LiDAR Quality Review Report

Burnett County, Wisconsin
Land Information Office

September 2016

PointCloud Mapping, LLC

Figure 3 – Duplicate Points

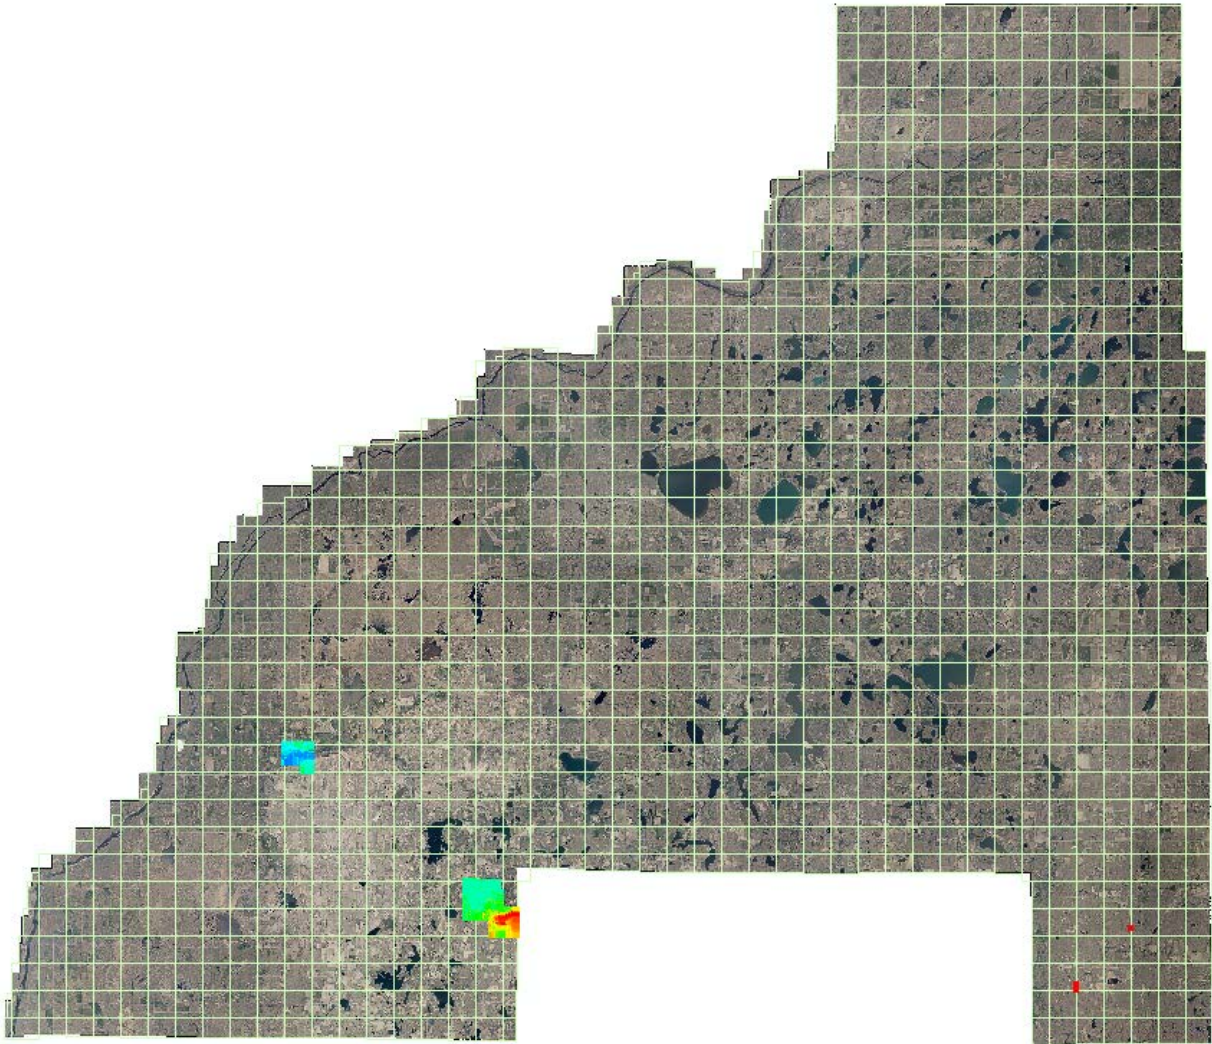
During an automated routines to check for duplicate points, it was noticed that 10 tiles had duplicate points ranging from counts of 1 to 4,861,622. These tiles are detailed in the “Burnett County Lidar Review 1-12-16 v2.xlsx” document. A similar situation exists for the Bare Earth las delivery. These duplicate points were removed from the data set.

Figure 4 Class 18 Points

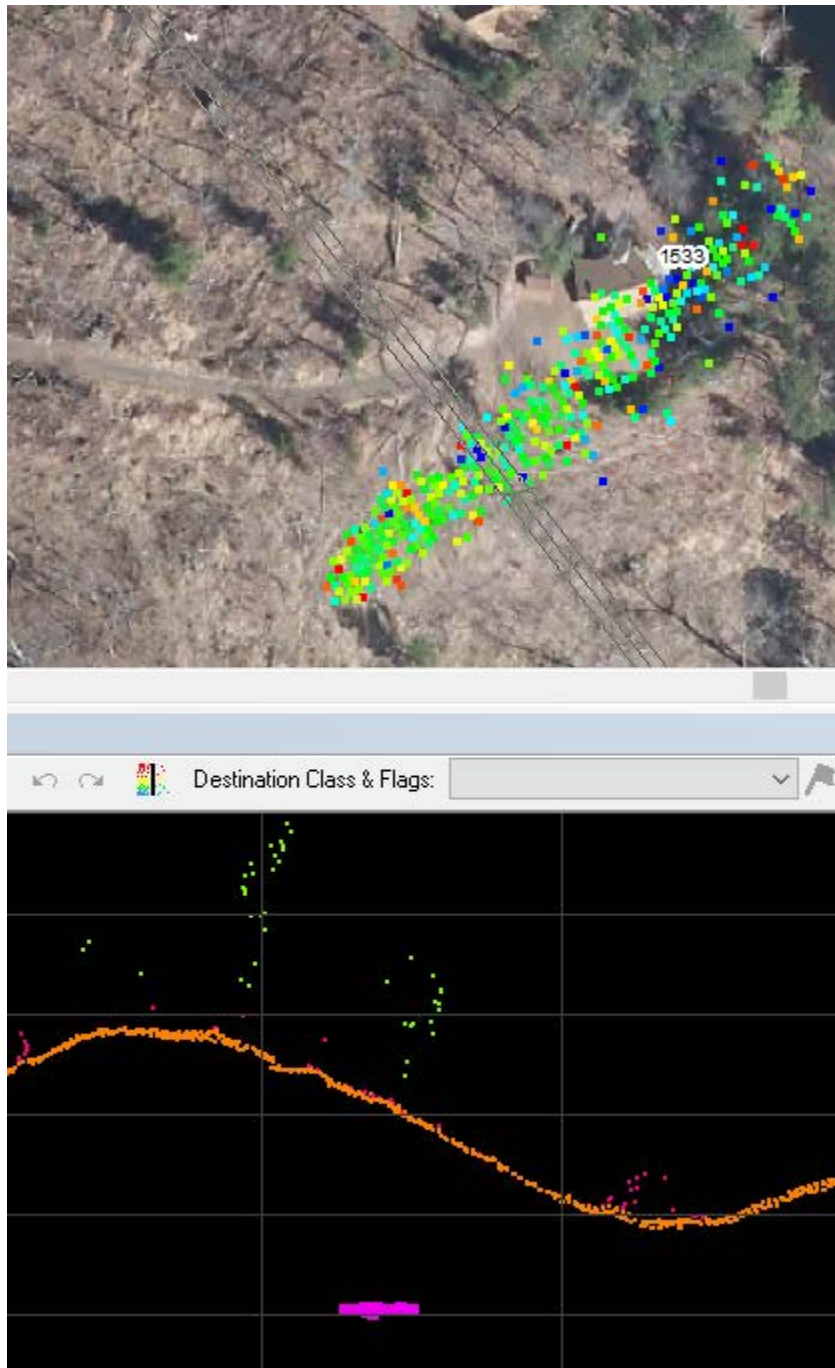
Tiles 1533, 3126, 3742, 3942, 3943, 3940, 2937, 2822, 1633, 3840, 1738, 3844, 3845, 3127, 1142, 1543, 2338, 3228, 1531, 1736, 1740, 3541 and 3941 contain Class 18 points. Figure 4 is an example of tile 1533, in plan and profile view, and the Class 18 points that fall below the ground surface. The traditional ASPRS numbering scheme uses Class 18 as high noise. Class 18 points were reclassified and placed in Class 7 (Low Points).

Figure 5 - Misidentified Bridge Points

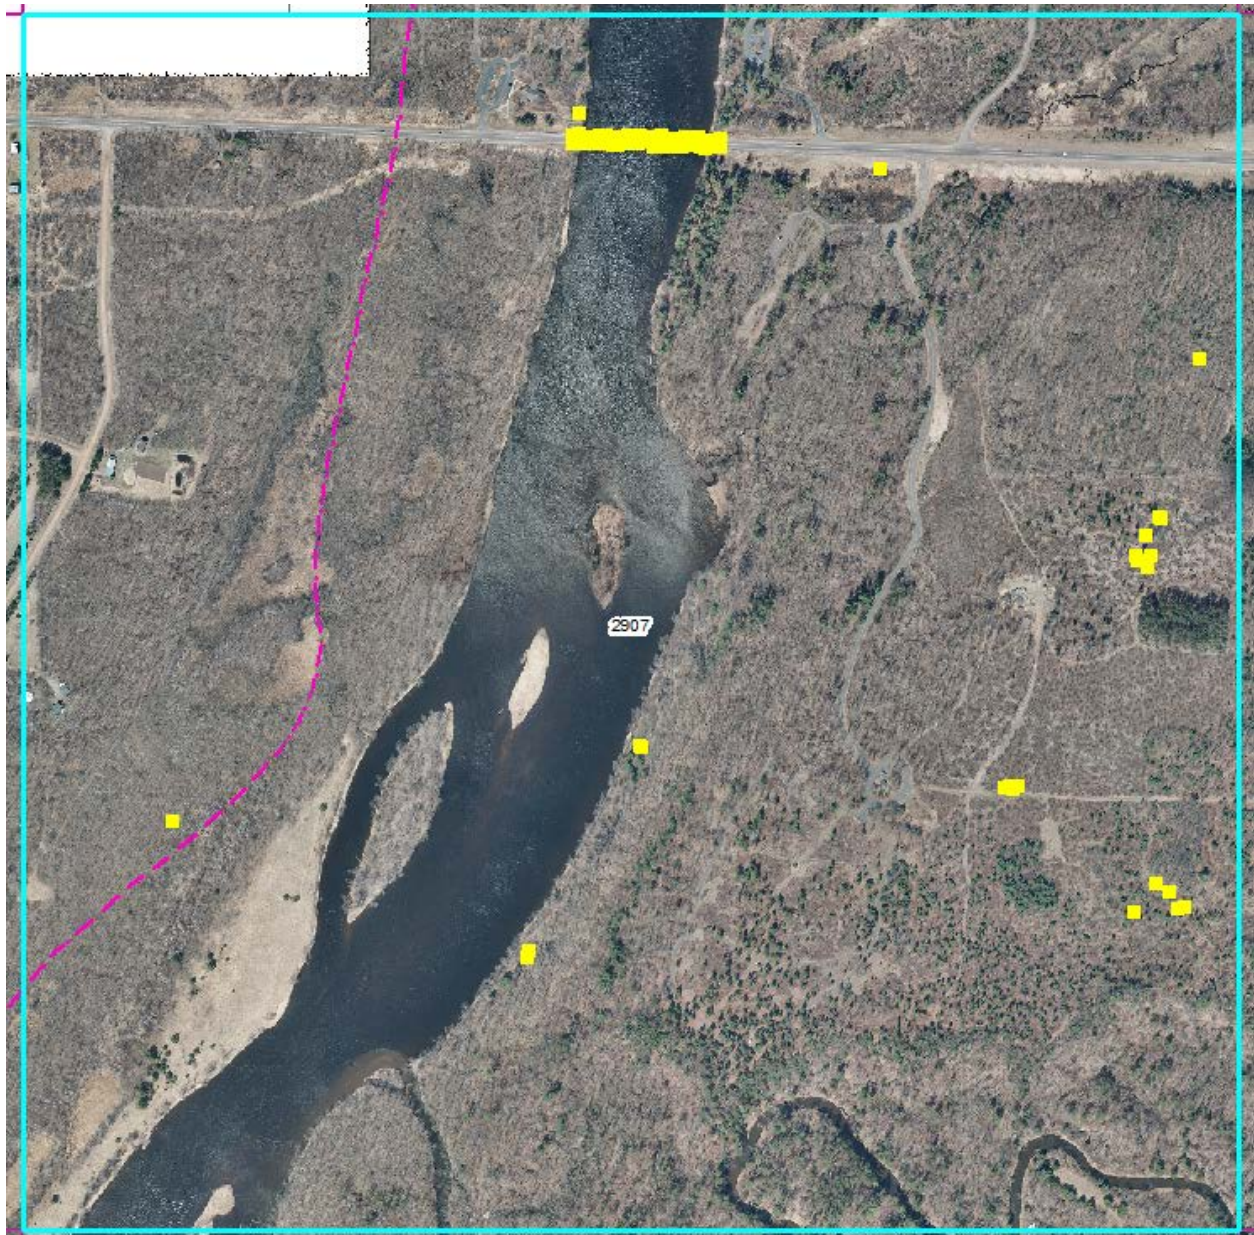
Figure 5 shows Class 17 points on tile 2907. In the northern portion there is a correctly classified bridge spanning the river. All of the other points in yellow are Class 17 but do not represent bridges. These spurious bridge points on this, and other tiles, were corrected.

Figure 6 - Missing Overlap Between Flight Lines

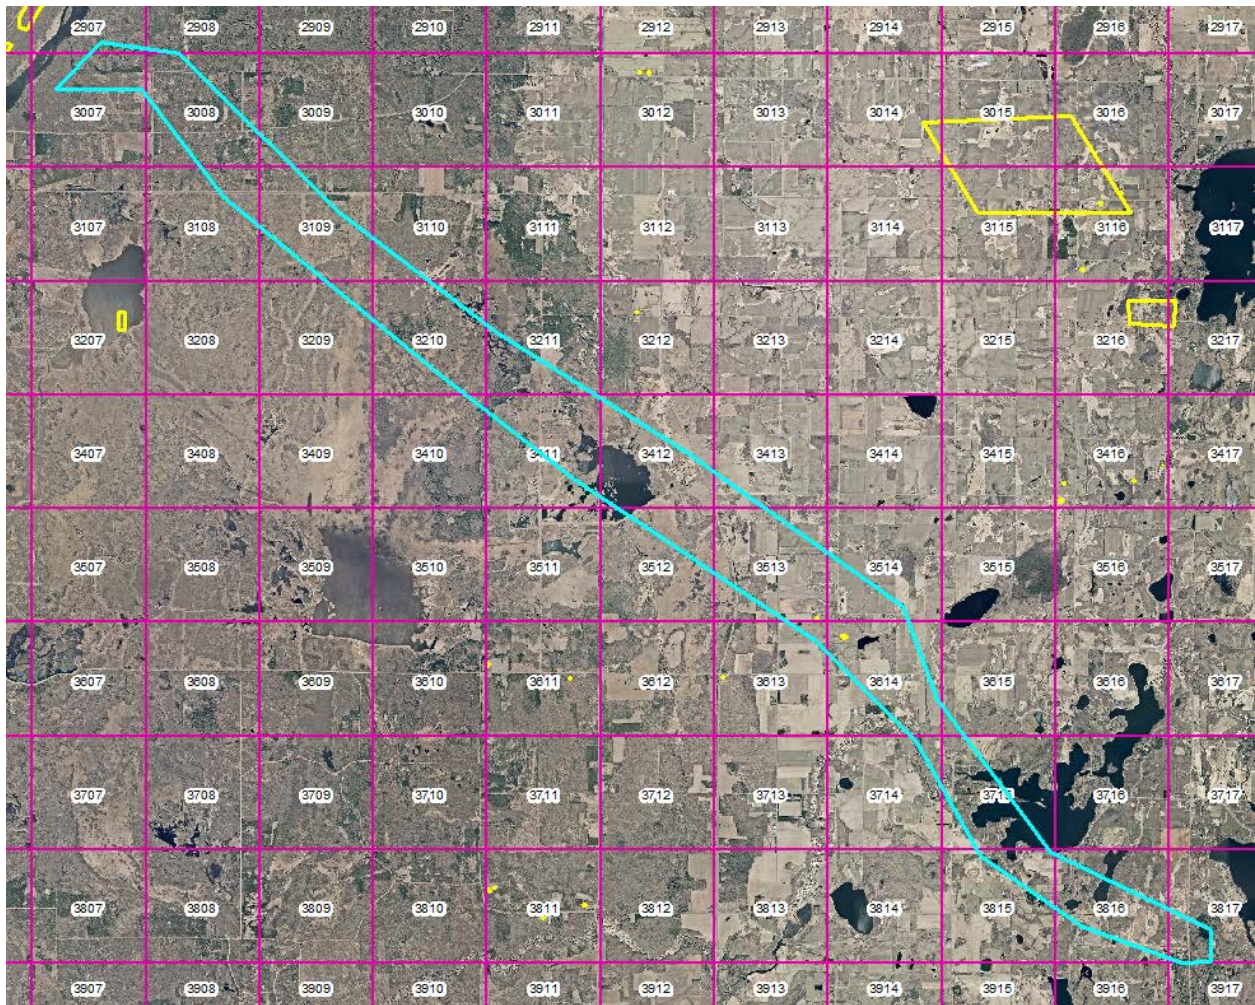
The following figure shows the area where north-south flight lines do not overlap the diagonal flight lines. The reason for having overlap between flight swaths is to 1) minimize the chances of having data voids and 2) allow the contractor to clip the outside edges of each flight swath where errors are most likely to occur. It is quite common to trim the data at the midpoint between adjacent flight swaths. In this particular case, Ayres clipped the flight swaths to a common line to make a butt join. While this is a bit unusual, it still passes the accuracy and point density standards.

Figure 7 - Gaps in Coverage

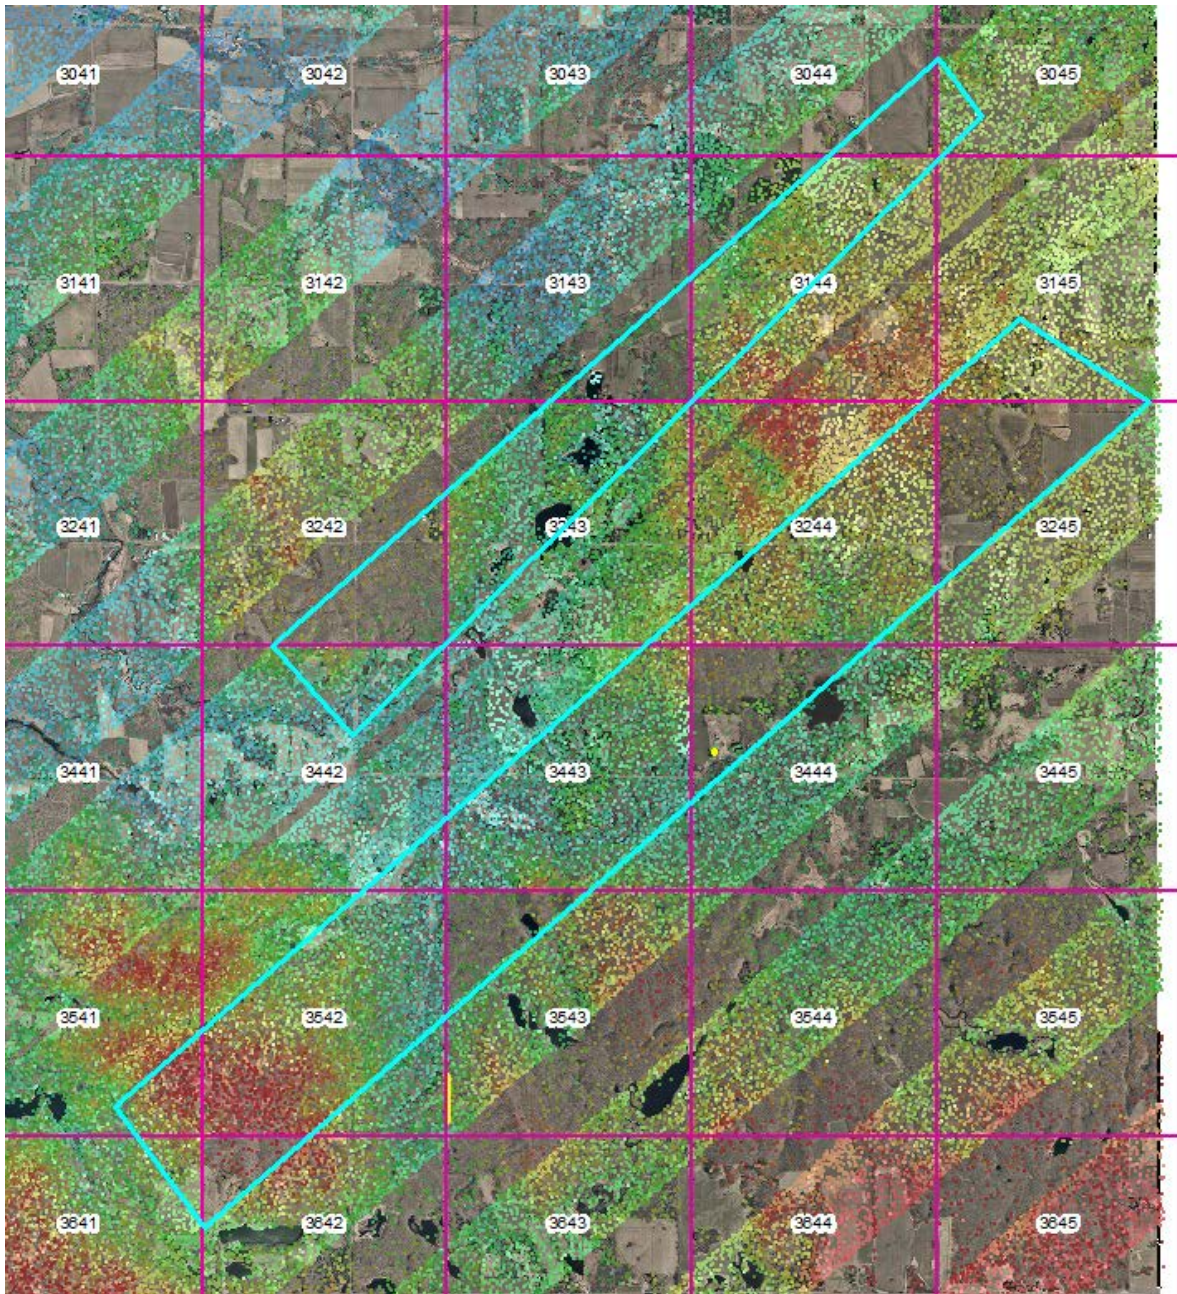
The following figure shows incomplete coverage in the corners of various tiles. The below figure shows Class 11 points (Withheld) to emphasize the unusual coverage in the corners of the tiles. As previously discussed, the normal process is to trim the overlap at the midpoint between the flight swaths. In this case it appears that the trimming was done periodically along the tile edges. The data coverage is complete and passes the accuracy standards and point density requirements, but the method used to trim the overlap area is unusual.

Figure 8 - DSM Issues

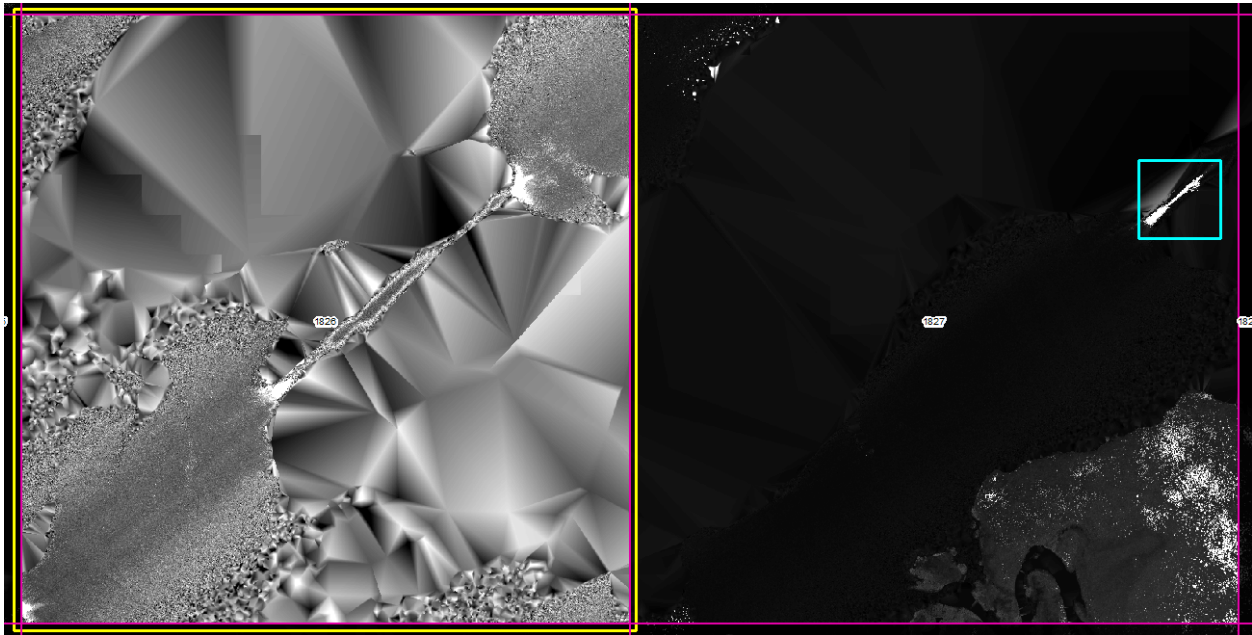
In Figure 8, the tile on the left the DSM contains elevation differences of 42 feet in a tile that only contains water. This comes from using Class 1 (Unclassified) points when generating the DSM. Since Class 1 contains anomalous points, it should not be used in the generation of other products. The tile on the right contains elevations that are 45 feet higher than the water surface from the Class 5 (High Veg).

With minor modifications, by Ayres, to the DEM's, DSM's and Intensity images, the final products passed the specifications.

Figure 9 - DSM and DEM Corner Issues

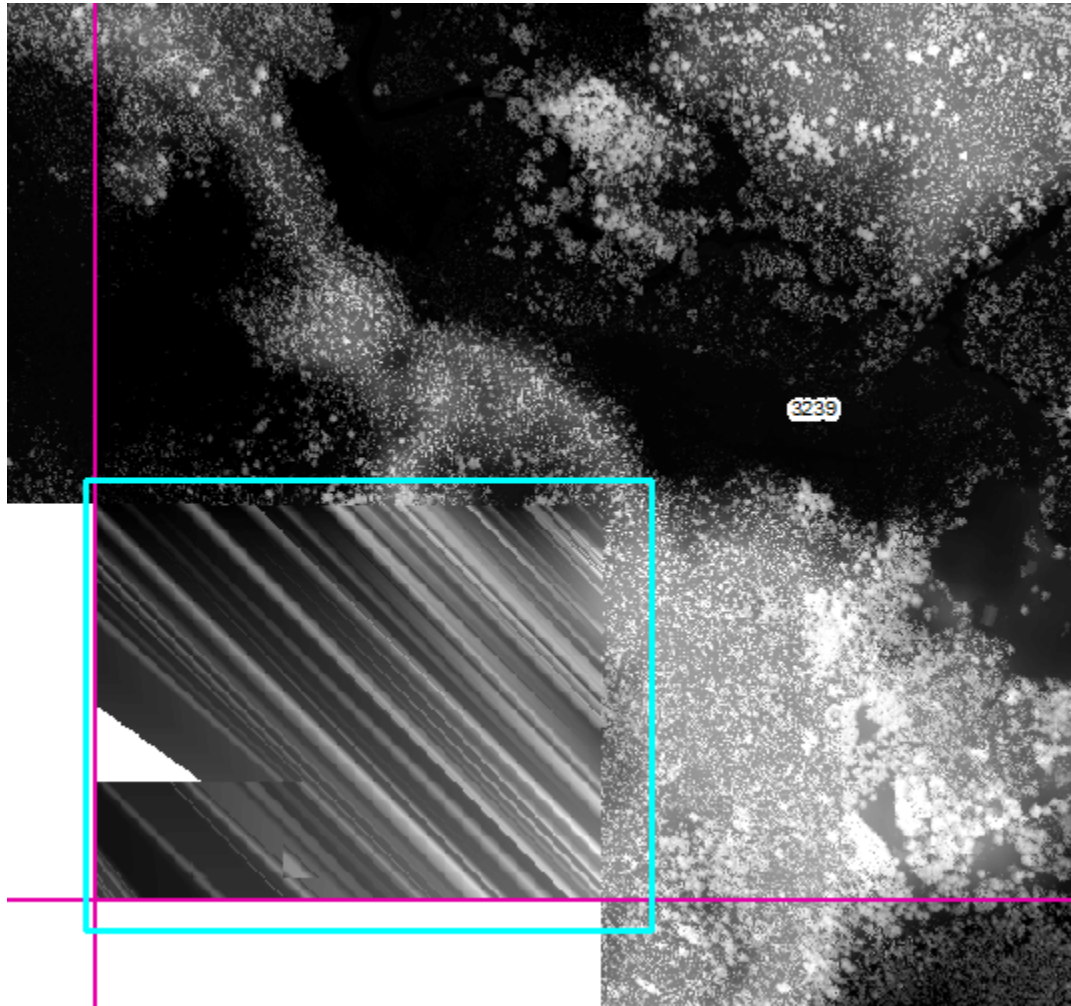
In Figure 9, there is a portion of the DSM and DEM at the corner that interpolates across the corner and provides incorrect elevations. All DEM's and DSM's were clipped to the project boundary and these corner issues were corrected.

Figure 10 - DSM Issues in Water

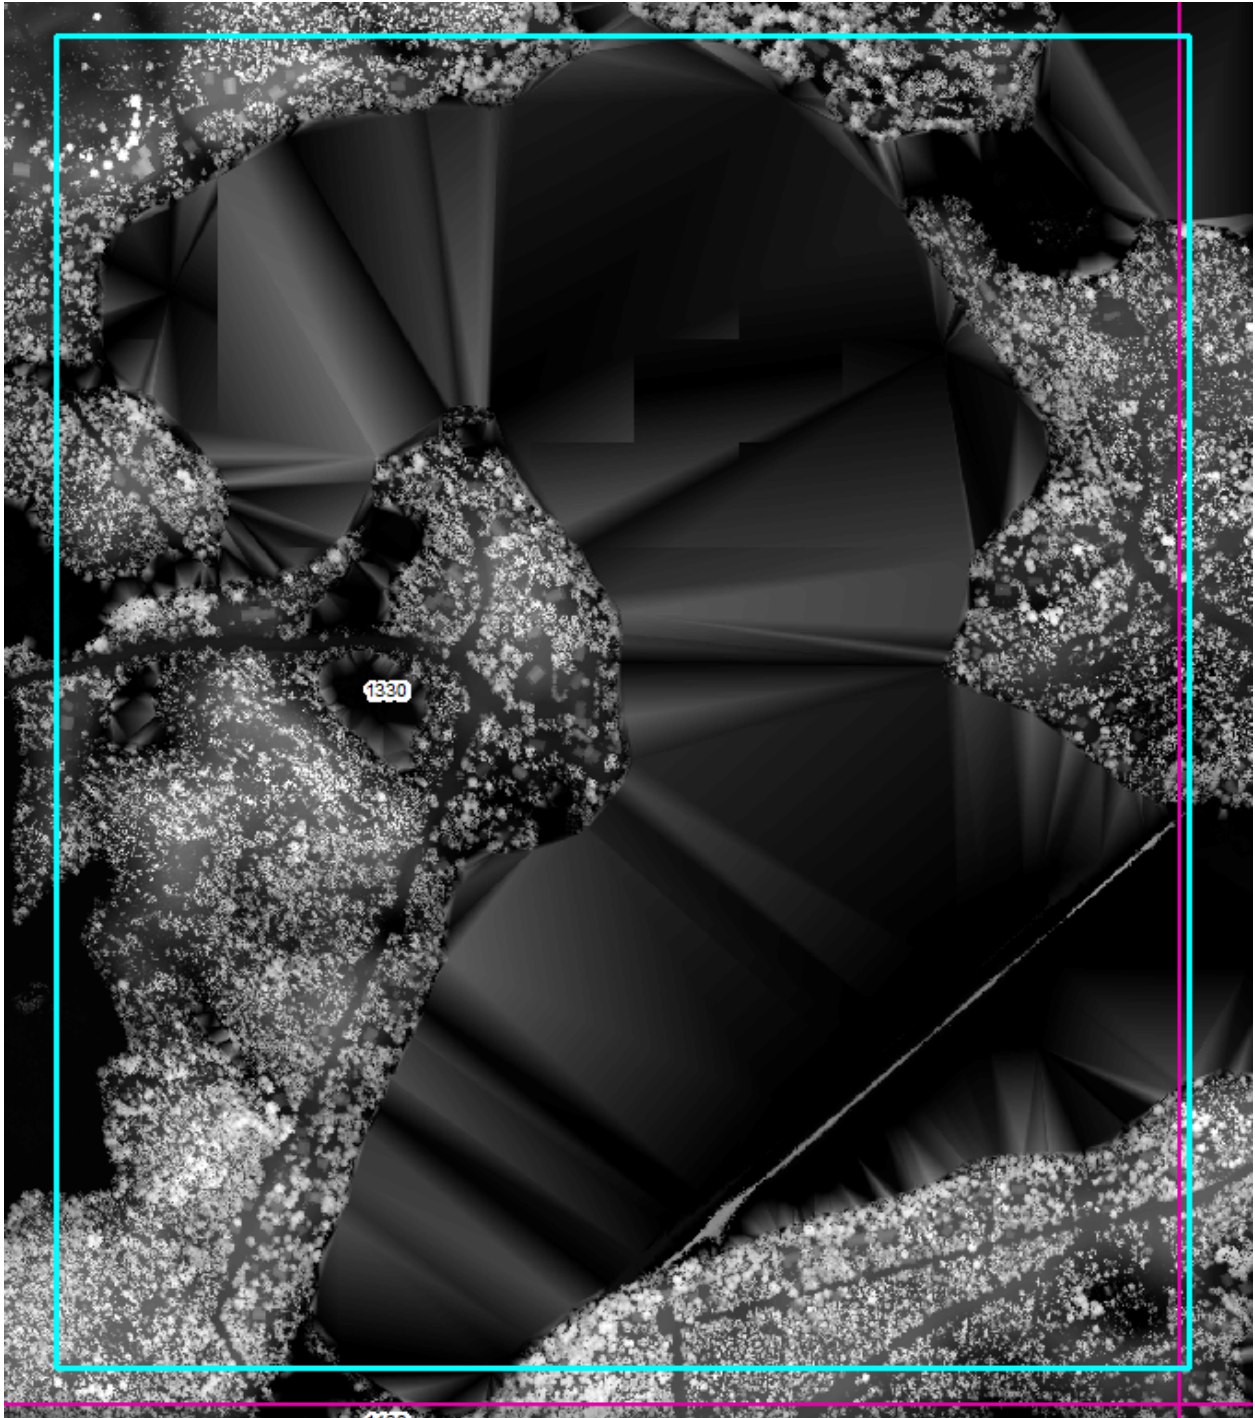
In Figure 10, the DSM contains triangles in the water. Apparently, points located in Class 1 are being used to generate the DSM and contains tree tops overhanging the water's edge. There can be two slightly different approaches to create DSM's along water bodies. First, you can select the first returns from the entire dataset. This would include trees that are overhanging the water body and thus create triangles in the water and the TIN triangles connect across the water body. This creates false elevations above the water. The second approach is to use the hydro enforced break lines to clip the overhanging trees and use the break lines to make the water "flat". This presents a more aesthetically pleasing DSM but it omits the overhanging trees. Both alternatives are technically correct and Ayres chose to use the first option. In addition, the strip in the SE corner of the tile is from erroneous points contained in Class 1. This error was corrected in the final data set.
